GOVERNMENT OF THE DISTRICT OF COLUMBIA
DEPARTMENT OF TRANSPORTATION

MEMORANDUM

SUBJECT: BZA Case No. 18902 – 2620 Bowen Rd. SE

Figure 1. Proposed First Floor Building Layout (Source: Applicant)

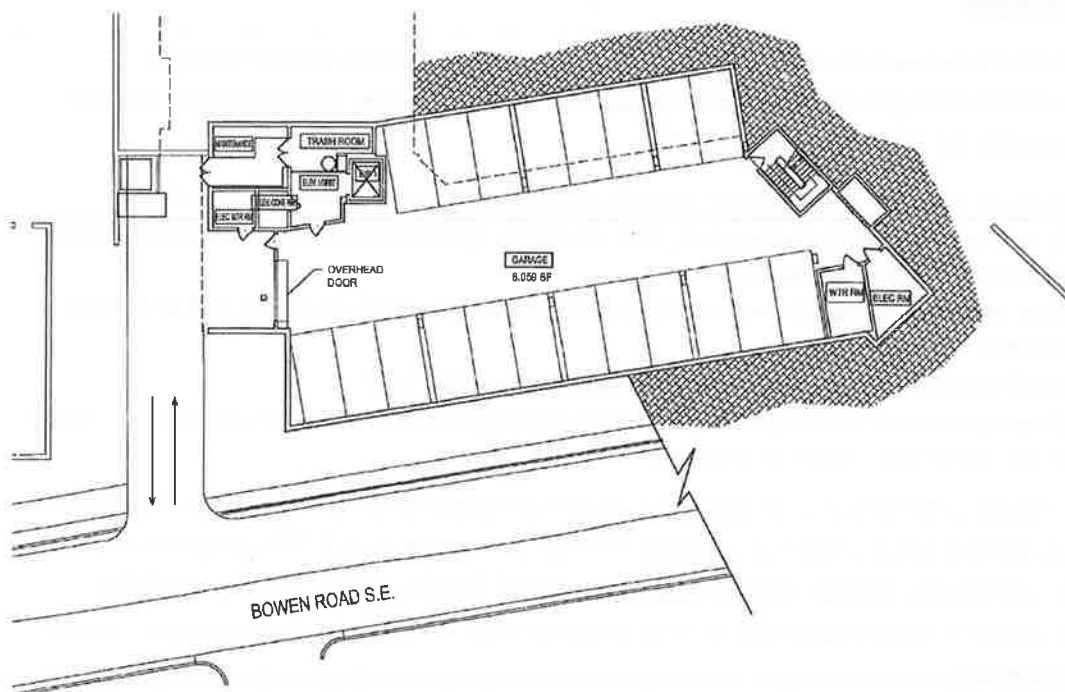
DDOT's practice is to accommodate vehicle loading in a safe and efficient manner, while at the same time preserving safety across non-vehicle mode areas and limiting any hindrance to traffic operations. For new developments, DDOT standards require that loading take place in private space and that no back-up maneuvers occur in the public realm. This often results in loading being accessed through an alley network. Here, however, the Site does not have access to an alley. The Site is accessed via a driveway entrance, as shown in *Figure 1*.

While not part of this zoning action, a workable loading concept is expected to show this building can be later permitted as part of the public space permitting process. The Applicant has shown the driveway

and garage entrance area will accommodate a 23' box truck, which is the most common service/delivery/moving truck anticipated. Therefore, it appears most loading can be accommodated on-site. Loading via larger trucks will require a permit for on-street loading and unloading.

DDOT expects the Applicant to comply with DDOT's standards for loading, the detailed design of which will be addressed as part of the permitting process for this property.
